**MAINE DEPARTMENT OF
INLAND FISHERIES AND WILDLIFE**

ADDENDUM NO. 1

**IMPROVEMENTS AT GRAND LAKE STREAM STATE FISH HATCHERY
GRAND LAKE STREAM, MAINE**

BGS PROJECT NO.: 3289-14

LOWER PAVILION WALL SECTIONS & DETAILS

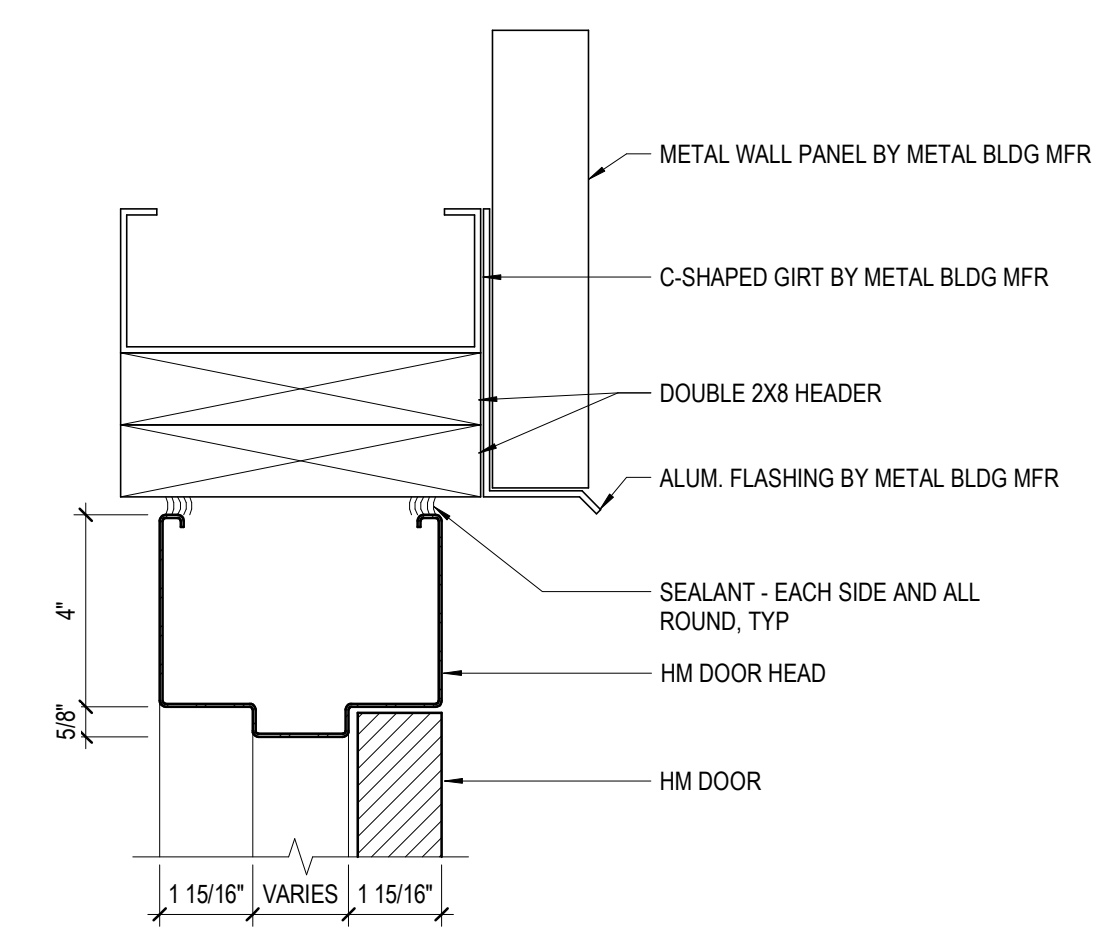
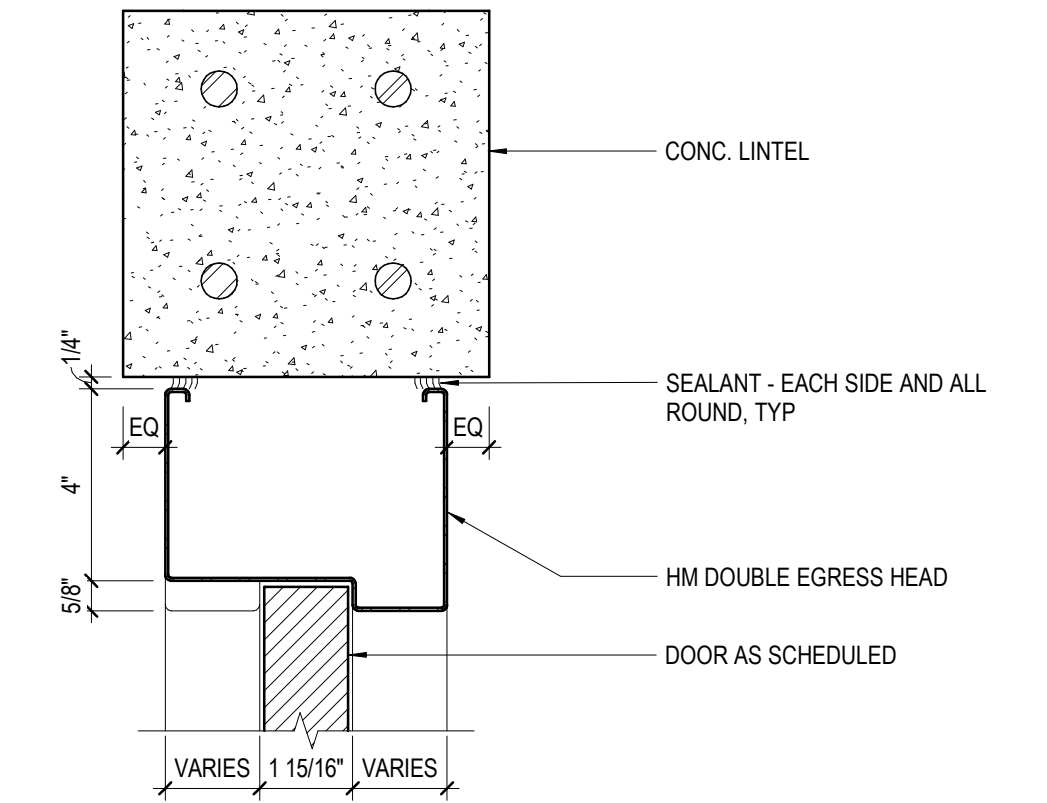
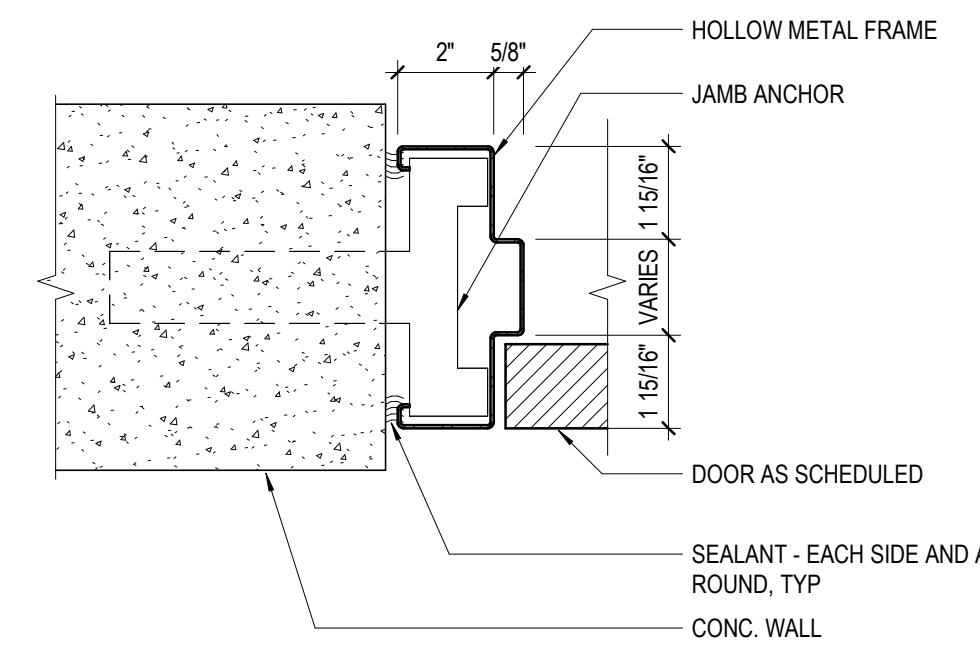
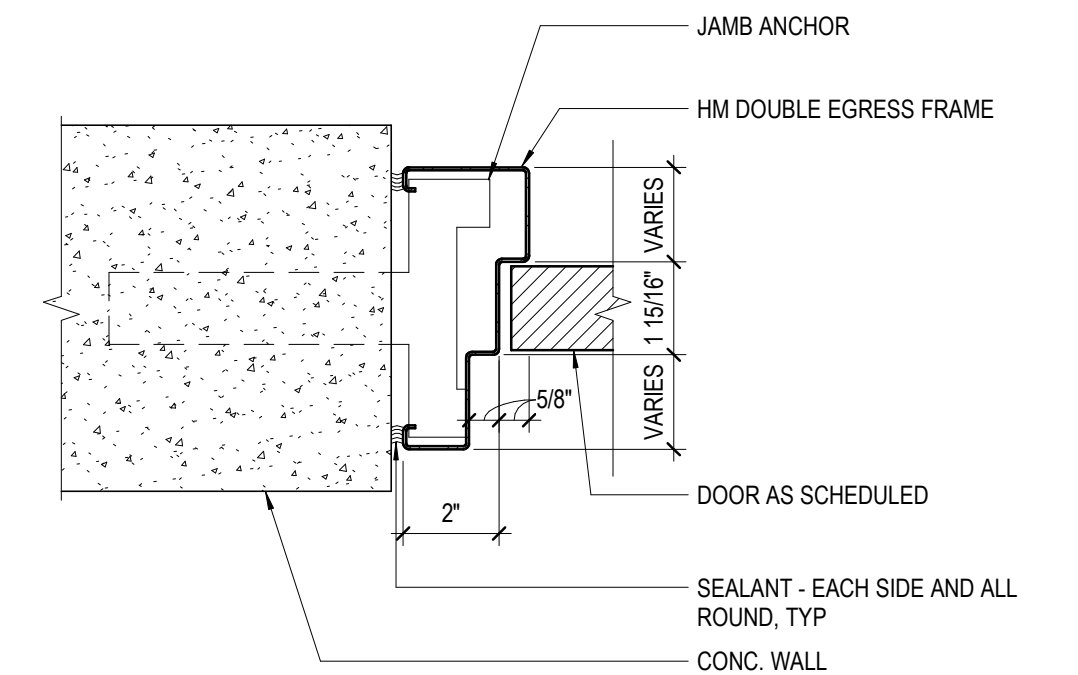
***UPDATE:** Sheet was updated to modify the callout for the bird netting.*
